## S96-1 CHANGES

### S96-2 SCOPE

CLONNY'S AT CLONTARF
CLONTARF RESERVE

ELEVATIONS

# SOUTH SIDE ELEVATION

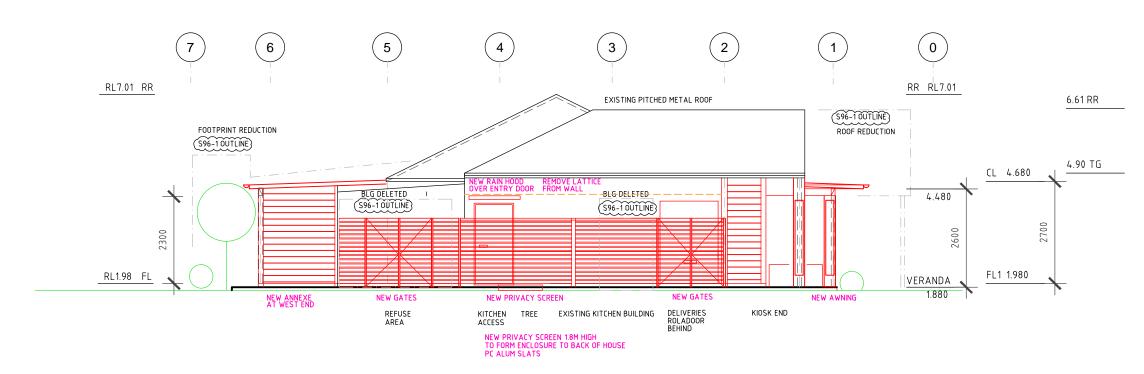
RETAIN EXISTING ROOF - 26 DEGREE PITCHED CUSTOM ORB PROFILE PAINT OR REPLACE AS REQUIRED REMOVE SKILLION ROOF & GUTTERS

NEW WIDER VERANDA EXISTING SKILLION 67sm PROPOSED SKILLION ROOF 82sm INC. AREA ACROSS KIOSK FORECOURT BONDOR SOLAR PANEL SPANDECK PROFILE 2 DEGREE PITCH NEW 150 CB HALF ROUND GUTTERS NEW 150 CB DOWNPIPES

NEW PC ALUM WINDOWS & DOORS TIMBER FRAME WALLS CLADDING - HARDIE LINEA BOARDS

DELETION / REDUCTION OF WORKS
VERANDA WIDTH REDUCED & LOWERED
KIOSK GABLE EXTENSION DELETED
FURNITURE STORE DELETED
REFUSE STORE DELETED
SOUTH END BATHROOM DELETED
REDUCTION IN FLOOR SPACE FOOTPRINT
REDUCTION IN PAVING AREA

REPLACE VERANDA, WIDEN BY 800 VERANDA TO HOUSE CHILDREN'S PLAY ZONE & STOREROOM – SOUTH END VERANDA FORMS NEW AWNING TO KIOSK NEW EAST END SCREENING FENCE
